UNITED STATES PATENT AND TRADEMARK OFFICE

Office Action Summary

09/863,013

DETAILED ACTION

FIG. 1

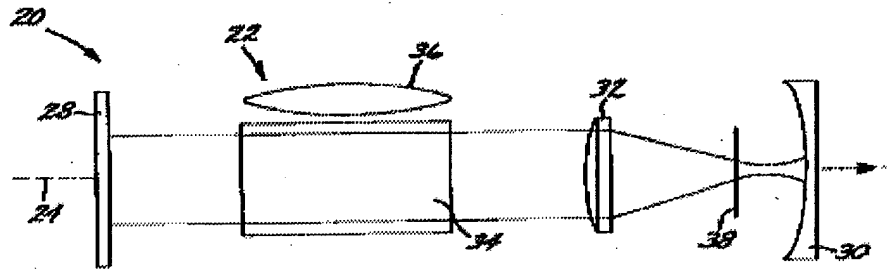
Regarding claim 16, Stultz et al. disclose a laser system, comprising:

a). a laser resonator cavity defined by a flat mirror (28) and an out coupler mirror (30), flat mirror (28) and said outcoupler (30) mirror oriented to form an optical resonant axis (24);

b). a lasing element (34) within the laser resonator cavity;

c) Optical pumping (36) means proximate to said lasing element

d). A saturable absorber Q-switch (38) lying along the resonant axis. (See Fig 1 below and column 3, line 14-21).

But Stultz et al. do not disclose the Q-switch including a monocrystalline lattice having a formula $Mg_{1-x}Co_xAl_yO_z$. However, Konstantin v. Yumashev and Thony et al. disclose a monocrystalline lattice having a formula $Mg_{1-x}Co_xAl_yO_z$ where x, y, z are still the range of the invention (See on the right column, first paragraph, page 1 of Konstantin v. Yumashev and column 2, line 38-47 in Thony et al.).
